HIROSE ELECTRIC CO., LTD.
2-6-3 Nakagawa Chuoh, Tsuzuki-ku, Yokohama, JAPAN**HIF3 Series Crimp Terminals – Product Consolidation**

[Change Details] HIF3 Crimp Terminals

June, 2026

Differences Before and After Change (Reel Terminals)

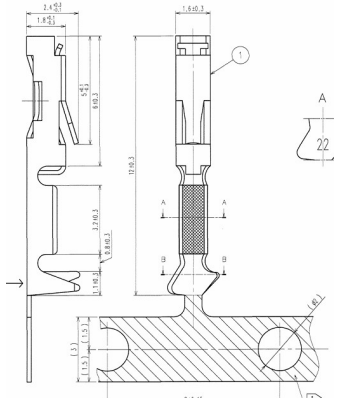
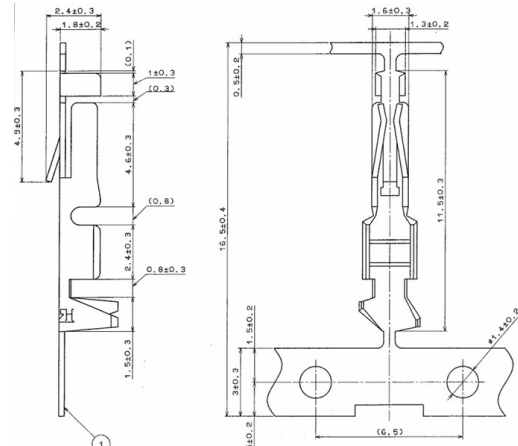
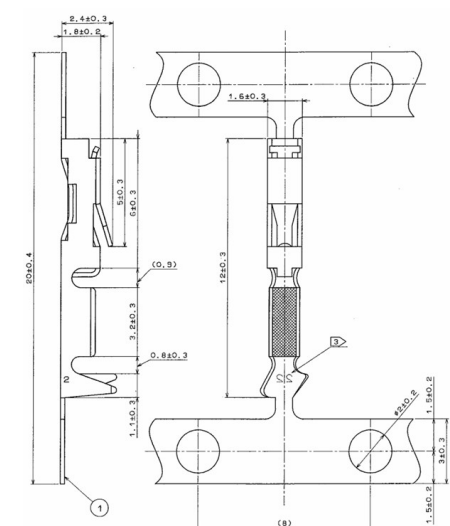
Type	Main Features
HIF3-***SCF 	• Full gold plating 0.2μm • 2-point contact (Top-bottom clamping) • Single-side carrier
HIF3-***SCFC 	• Partial gold plating 0.2μm • 2-point contact (Left-right clamping) • Double-side carrier

Type	Main Features
HIF3-***SCFA 	• Partial gold plating 0.2μm • 2-point contact (Top-bottom clamping) • Double-side carrier

Differences Before and After Change (Applicator)

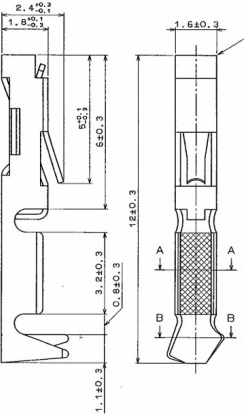
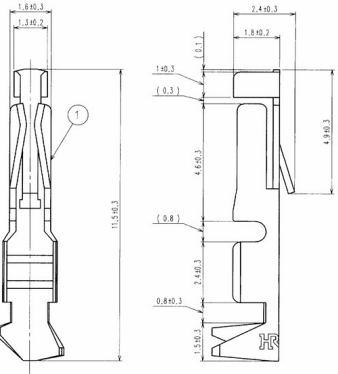
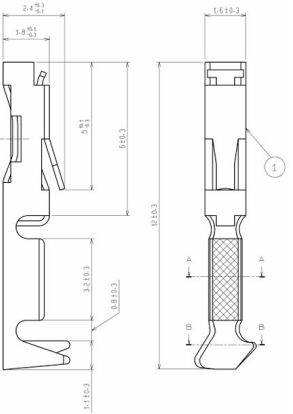
Since Partial plating products have carriers on Double sides, they cannot be crimped with your current applicator. We will perform the modification work, so please contact your Hirose sales representative.
